Subject: HESITATION / IDLE VIBRATION DUE TO CRACKED ENGINE MOUNT	Bulletin No: 01-021/06
	Last Issued: 6/13/2006

2004-2005 RX-8 vehicles with VINs lower than JM1FE*****154999 (produced before May 6, 2005)

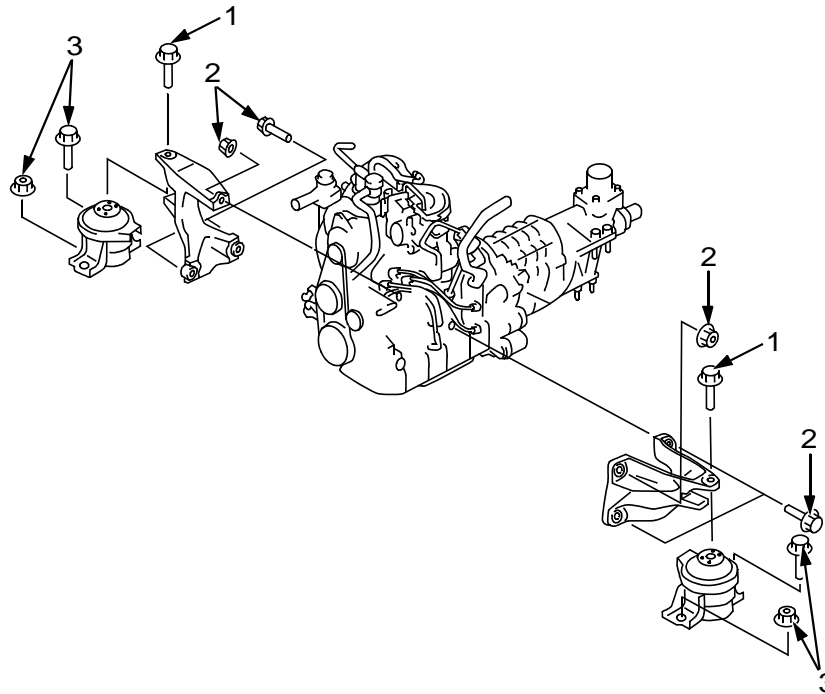
Depending on the driving condition or engine condition, the RH side engine mount rubber may deform. As a result, the RH side engine mount can crack. As a mass production change, the material of the engine mount rubber has been changed. To provide durability of the replaced RH engine mount, an engine bracket with insulator for RH side has been established together with modified engine mount for the LH side.

Customers having this concern should have their vehicle repaired using the following procedure. Replace the RH engine mount and modified RH engine bracket together with the LH engine mount.

7. On RH side of engine, remove bolts/nuts in the following order:
 - a. Engine mount bracket-to-engine mount (1). - **Tightening Torque: 37-52 N.m (28-38 ft-lb)**
 - b. Engine mount bracket-to-engine (2). - **Tightening Torque: 43-61 N.m (32-45 ft-lb)**
 - c. Engine mount-to-front sub frame (3). - **Tightening Torque: 45-63 N.m (33-46 ft-lb)**

8. On LH side of engine, remove bolts/nuts in the following order:
 - a. Engine mount bracket-to-engine mount (1). - **Tightening Torque: 37-52 N.m (28-38 ft-lb)**
 - b. Engine mount-to-front sub frame (3). - **Tightening Torque: 45-63 N.m (33-46 ft-lb)**
9. To install, reverse removal procedure.
10. Verify repair.
